Submission to WestConnex New M4/M5 EIS, project number SSI 16\_7485

Attn: Secretary, re: WestConnex M4/M5 EIS, Project Number SSI 16\_7485.

## SUBMISSION OF OBJECTION TO WESTCONNEX M4/M5 LINK EIS.

**Figure 1: Proposed alternative design to remove traffic lights at M4-M5 Link (south) entry/exit from City West Link**

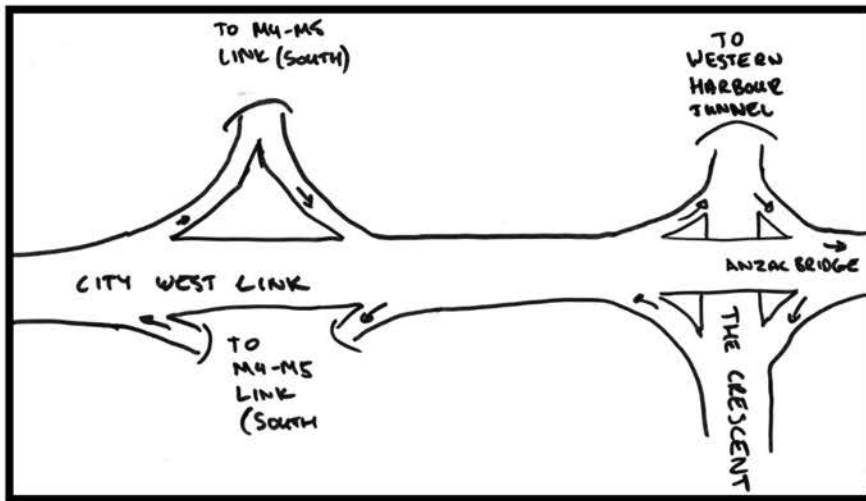
The EIS (page 1-11, Figure 1-3) and the "M4-M5 Link Concept Design" (May 2017) imply that the Rozelle interchange connection from the City West Link to the M4-M5 Link (south) requires an additional set of traffic lights on City West Link. This will result in:

- Integrate the entry exit points for the M4-M5 Link (south) and the entry/exit point for the future proposed Northern Beaches link, reducing the interruption to traffic flow (preferred option).
- Change the design of the proposed M4-M5 Link (south) to remove traffic lights as presented in Figure 1 below.

The EIS must not be approved until this design flaw is assessed – or an approval condition of the EIS must be a design changed to remove traffic lights at this entry/exit point.

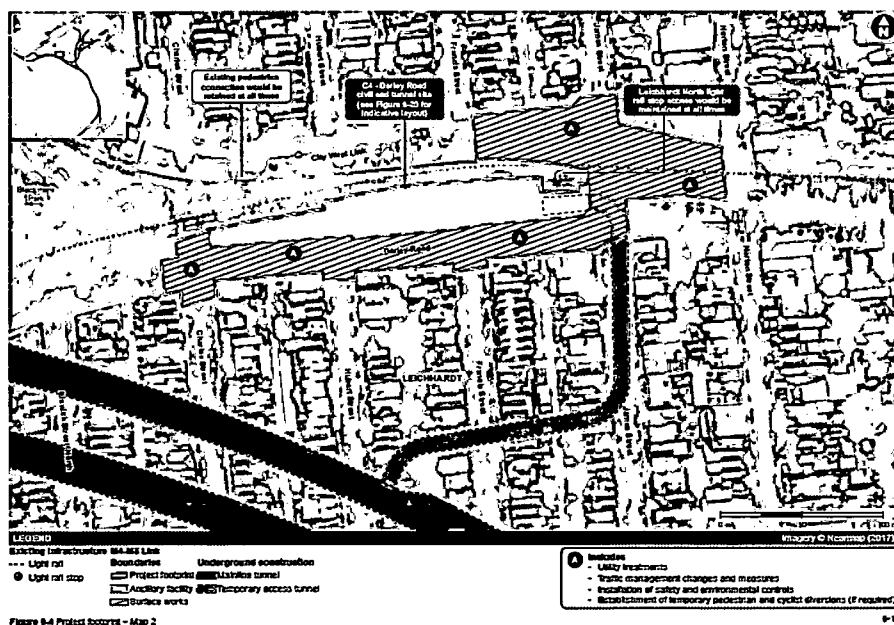
1. I object to the EIS because it fails to describe the temporary changes to Darley Road, Leichhardt to enable access to and from the ancillary facility that would likely be required in relation to the Darley Rd site and instead allows for the final plan to be decided by the contractor.

The EIS states in 6.5.8 Darley Road civil and tunnel site (C4) that:

'Temporary changes to Darley Road to enable access to and from the ancillary facility would likely be required. These may include changes to line marking to provide a temporary turning lane for construction traffic and temporary diversions to the pedestrian path on the northern side of Darley Road. These would be confirmed during detailed design following the appointment of a design and construction contractor and in consideration of the safety and function of the road network, maintaining access to the Leichhardt North light rail stop and providing for continued pedestrian and cyclist movement.'

It is not clear how continued access, pedestrian and cyclist movement will be preserved and I am concerned that the impacts have not been correctly identified and assessed by the proponent.

Figure 5-1: Summary of benefits over time, WestConnex scenario, (\$2015)

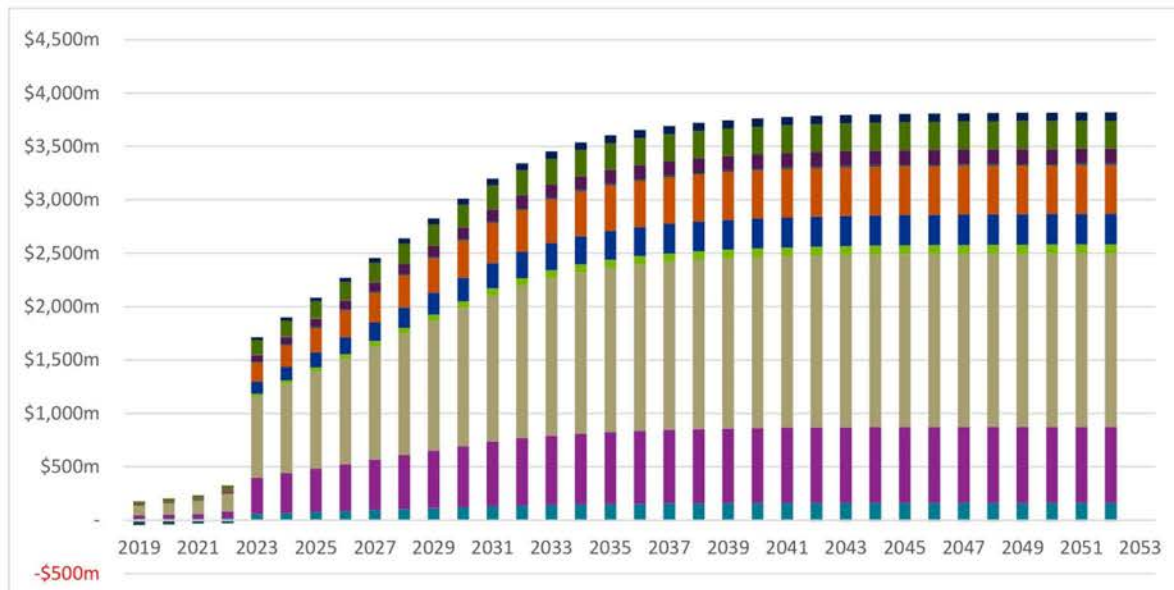
If the figure of 2.94:1 were an accurate reporting of the benefit attributable to Stage 3, then this would indicate almost the entire benefit claimed for the project is approximately the same as the benefit attributed to Stage 3, meaning that Stages 1 and 2 individually have negligible benefit.

Figure 5-1 in the *WestConnex Updated Strategic Business Case* supports this. The benefits of Stage 1 and 2 alone are a small fraction of the supposed benefits of the whole project:

The *WestConnex Updated Strategic Business Case* says that “[t]he significant jump in benefits in the year 2023, is representative of the increased scale of benefits being ‘unlocked’ by the opening of the M4-M5 tunnel link (Stage 3).” (KPMG-43).

Figure 3: St Peters Interchange Network under various scenarios (Source: Appendix H)

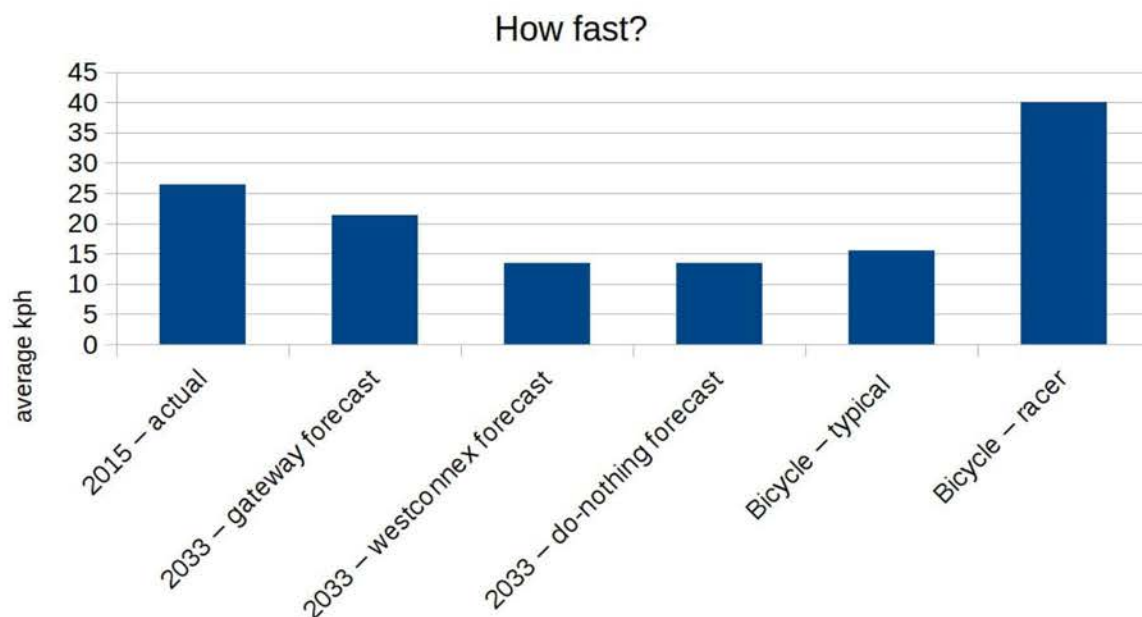
The model does not accommodate the forecast traffic, and the network upon which the recommendation to proceed is based, is not the network proposed in the EIS.

The EIS shows that current average peak speed in the network around St Peters during the AM and PM peak hours is around 27kph (26.8kph in AM Peak, Table 8-13; 26.1kph in PM Peak, Table 8-14). With the Airport Gateway (which is not part of this project) speed is forecast to drop to about 22kph (Tables 12-21 and 12-22). Without the Gateway, whether or not WestConnex is built, speed is forecast to drop to about 12kph (Tables 10-25 and 10-26). By way of comparison, an average cyclist can manage 15.5kph - and a serious cyclist a lot more than that.

However, the modelling behind this forecast is incomplete. The modelling does not resolve all ‘unreleased vehicles’. An unreleased vehicle is one that could not enter the modelled network because of congestion - it is either stuck in a driveway, unable to exit, or stuck in a queue of traffic at the border of the network.
